Meeting January 11, 2023
Agenda #8, Legistar #69208

I'm writing in regards to the Final Land Use Application before the UDC requesting a change in zoning from TR-V1 to Planned Development (PD) District at 2165 Linden Ave. The UDC is charged with recommending approval of both the design of the development as well as the request for the PD zoning.

View of Division Street from Atwood Ave. to Linden Ave. walking north from Atwood Ave.
 (2 story commercial building, 1 ½ story residential, 1 story residential, proposed 3 ½ story building)

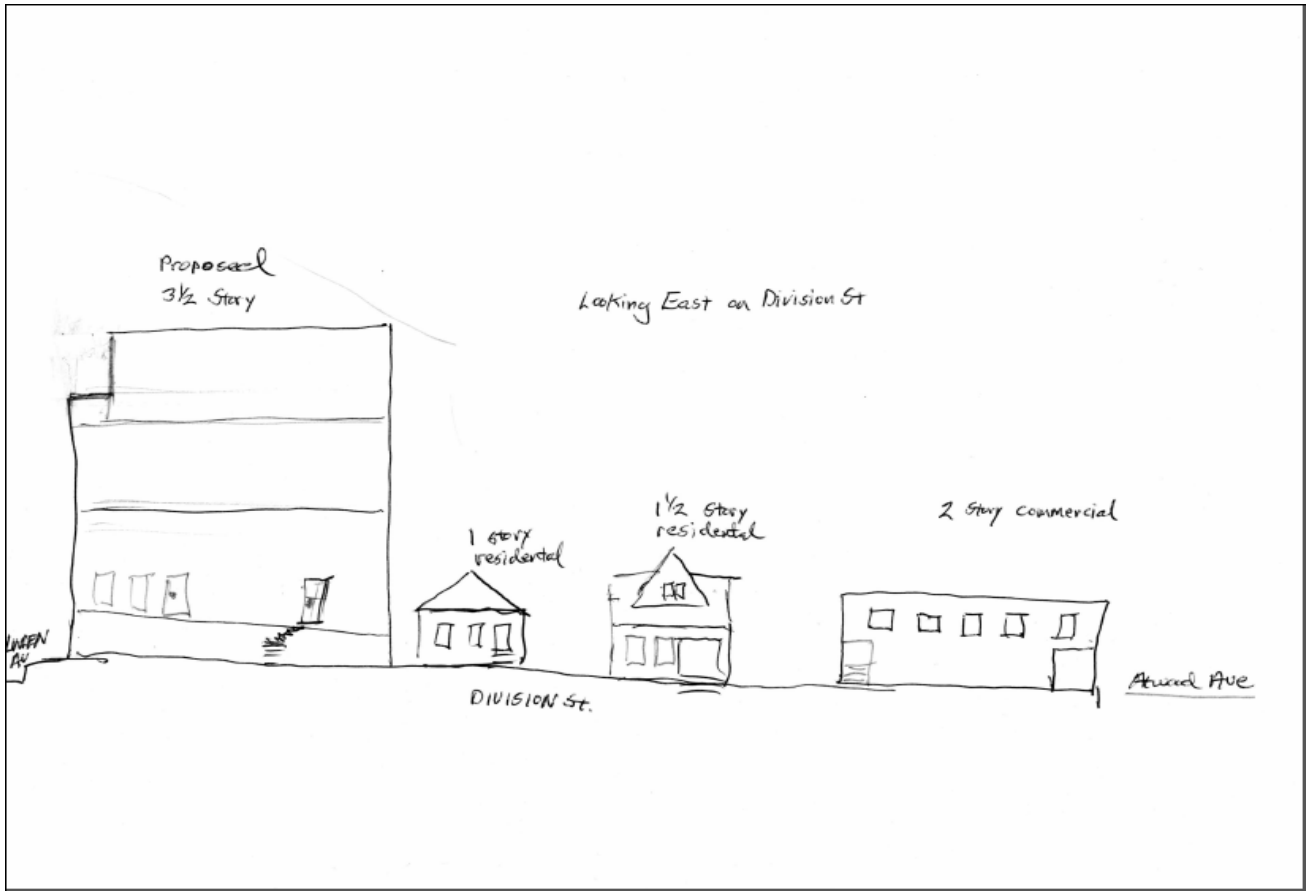
This is not a level lot and slopes down towards Division Street. The building of 3 stories on the Division Street side is actually higher than “3 stories” relative to the other houses on Division St. There is a wall and 2 sets of stairs to enter the units on Division Street to adjust for the slope, thus making it actually higher from the street level than Dunning Street. The renderings fail to show a view from that perspective. The small one story house in the rendering is a white structure suggesting a garage or storage shed. It is therefore NOT compatible, nor transitional with the surrounding area. The only mention of transition is on the southwest side with the Cornerstone Building.

The renderings are deceptive. There is no longer a stepback for the third floor on the south side of the building. This actually creates a taller building on that side therefore even less of a transition.

**See the drawing on the next page as there is no rendering of the residences of Division Street from Atwood Ave going north to Linden Ave. in the Land Use Application.
